INDEX

"FIXES ARE GREAT IN '98"

INTRODUCTION

Figure 2

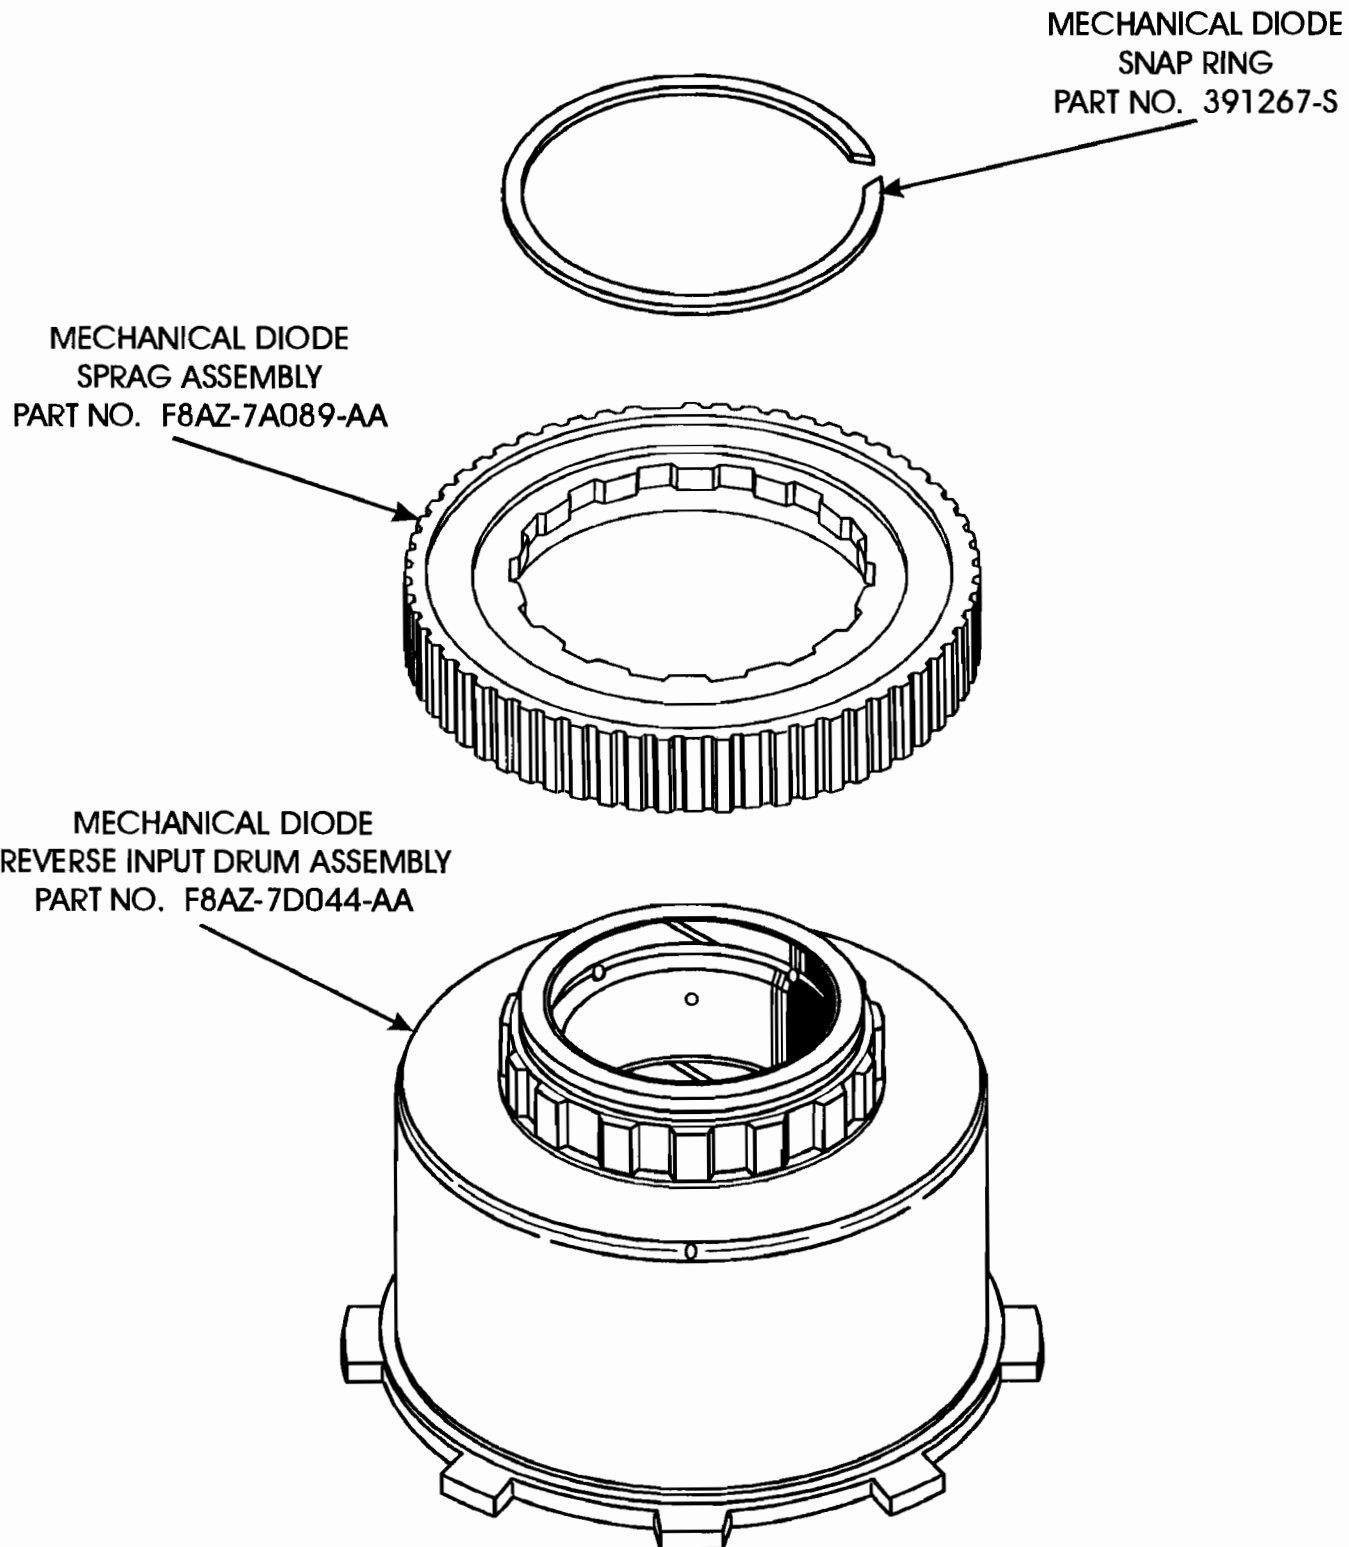
- (1) **MECHANICAL DIODE SPRAG ASSEMBLY** - Totally new design to replace the previous design intermediate roller clutch in AODE and 4R70W transmissions (See Figures 1 and 2).
- (2) **REVERSE INPUT HOUSING** - New design housing with "Splines" in place of the previous inner race, to accommodate the new design mechanical diode sprag assembly. Refer to Figures 1 and 2.
- (3) **RETAINING RING** - No dimensional changes on the snap ring, you still use the original snap ring. When installed, the mechanical diode assembly may move back and forth approximately .010" and this is normal (See Figure 2).

Figure 1

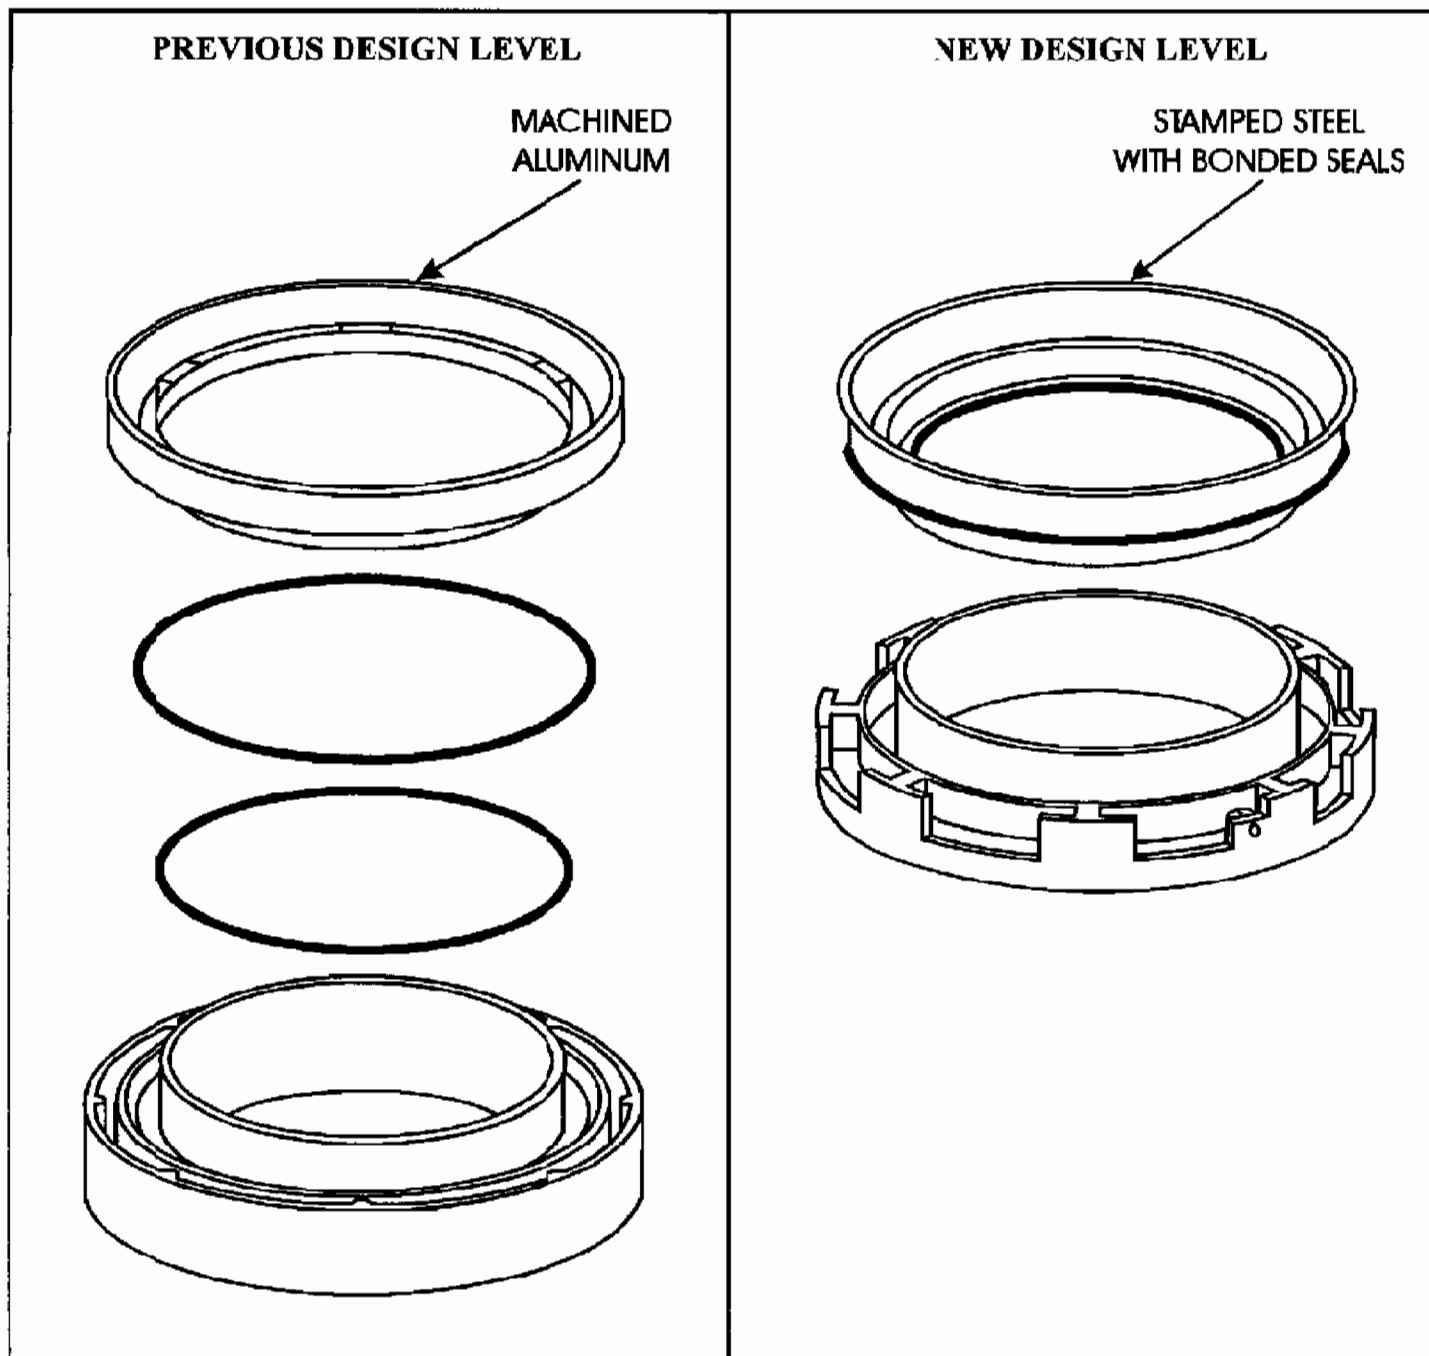
CHANGE: Some 1996-1997 vehicles equipped with the E4OD transmission were built with a new design level overdrive clutch piston, with the seals bonded to the piston (See Figure 1).

- (1) OVERDRIVE PISTON - Now stamped steel with moulded rubber inner and outer seals on the piston assembly, instead of the previous machined aluminum, as shown in Figure 1.
- (2) OVERDRIVE/INTERMEDIATE CLUTCH CYLINDER - Major casting changes to clutch cylinder, to accommodate the new design level bonded piston, as shown in Figure 1.

Figure 1

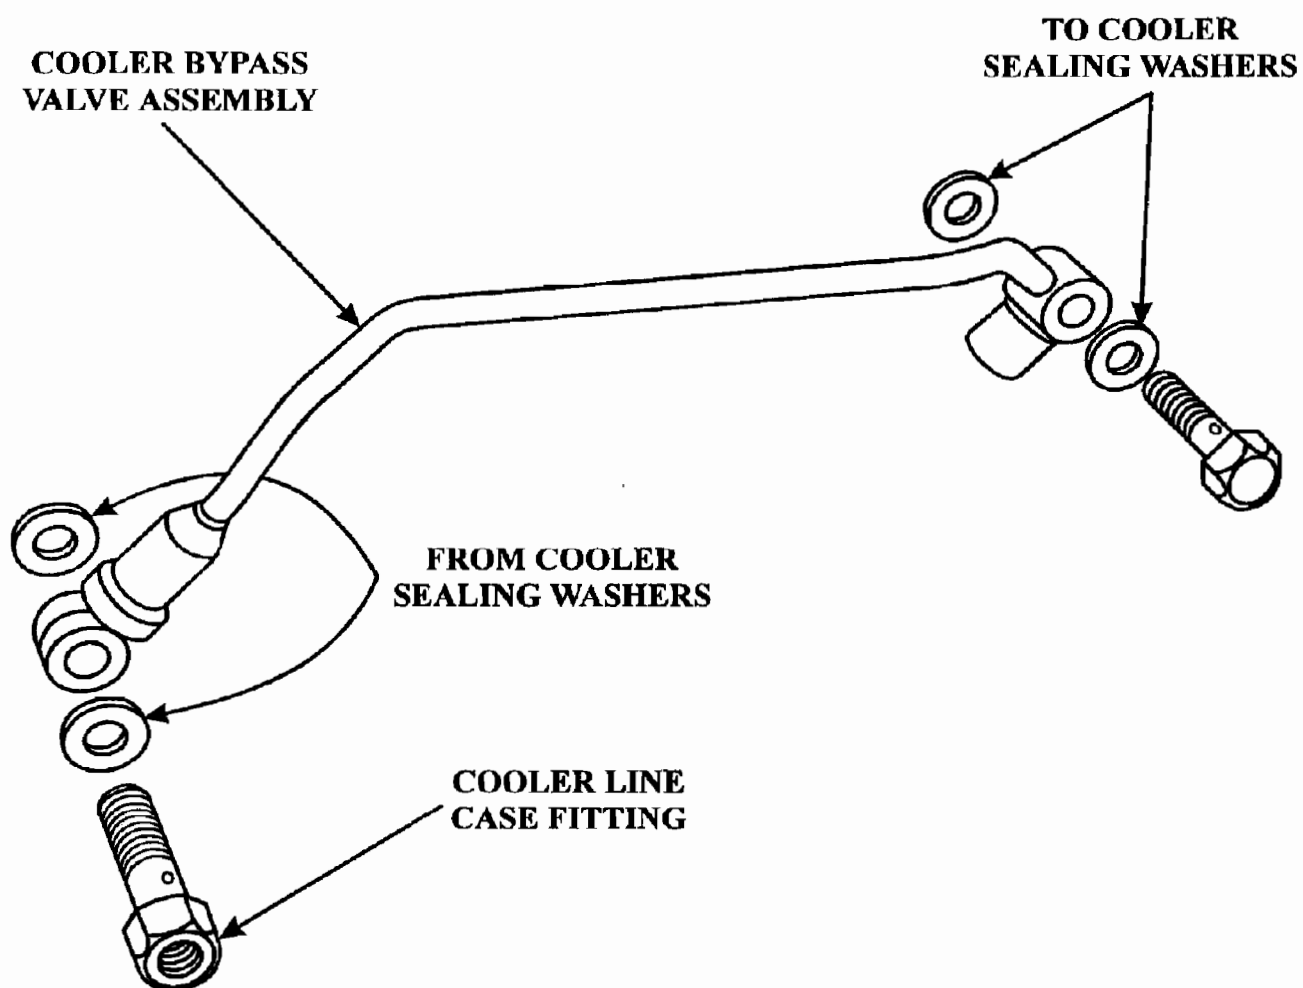
CHANGE: Some 1997 Econoline, Expedition, F-150 Trucks and F-250 Trucks have been equipped with a Cooler Bypass Valve Assembly that requires sealing washers on both the "To Cooler" end and "From Cooler" end of the bypass valve assembly, as shown in Figure 1.

- (1) **COOLER BYPASS VALVE ASSEMBLY** - Added between the cooler line fittings in the case, to increase lube flow during cold weather operation (See Figure 1).
- (2) **CASE FITTINGS** - Requires special case fittings to retain the "Banjo" ends of the cooler bypass valve assembly into the transmission case (See Figure 1).
- (3) **SEALING WASHERS** - Requires sealing washers on both of the "Banjo" ends of the cooler bypass valve to seal properly (See Figure 1).

If a removed Cooler Bypass Valve has an "O" ring installed, remove the "O" ring prior to re-installing the assembly. The "O" rings are only used to hold the sealing washers in place for shipping purposes. If the entire Cooler Bypass Valve requires replacement, be sure to remove the shipping caps and "O" rings prior to installation.

Figure 3

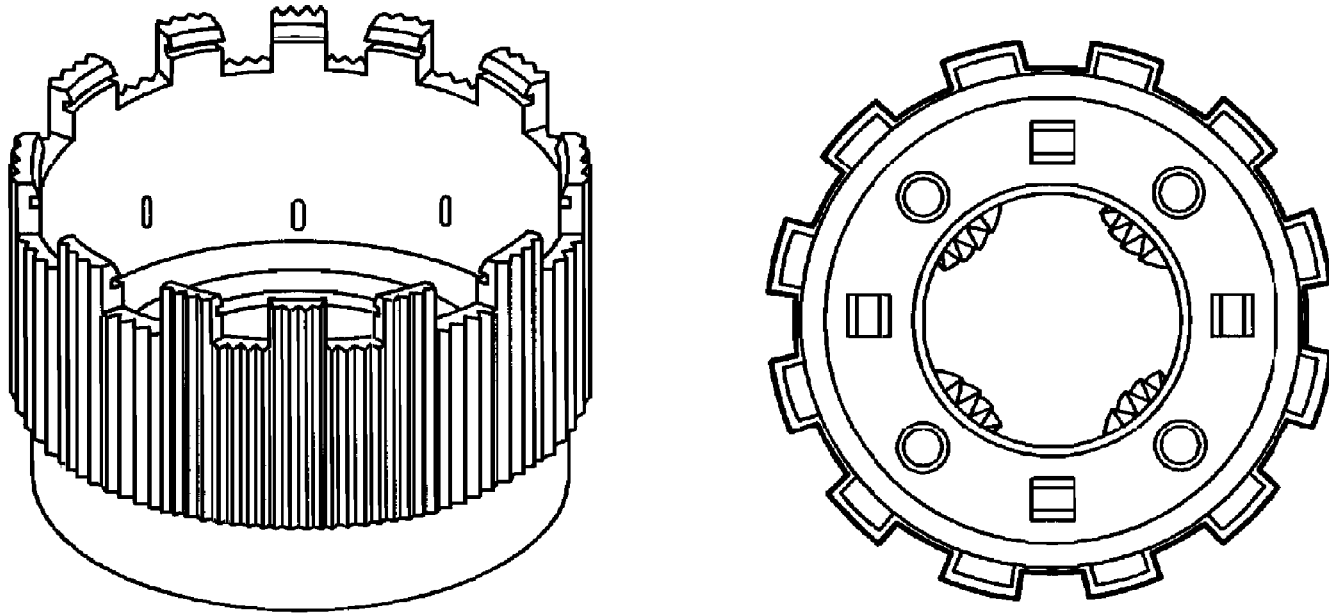
- (5) REAR PLANETARY CARRIER - New design level has narrow teeth on the outside diameter instead of the previous wide teeth, to accommodate the new design reverse clutch hub. Refer to Figures 3 and 4.
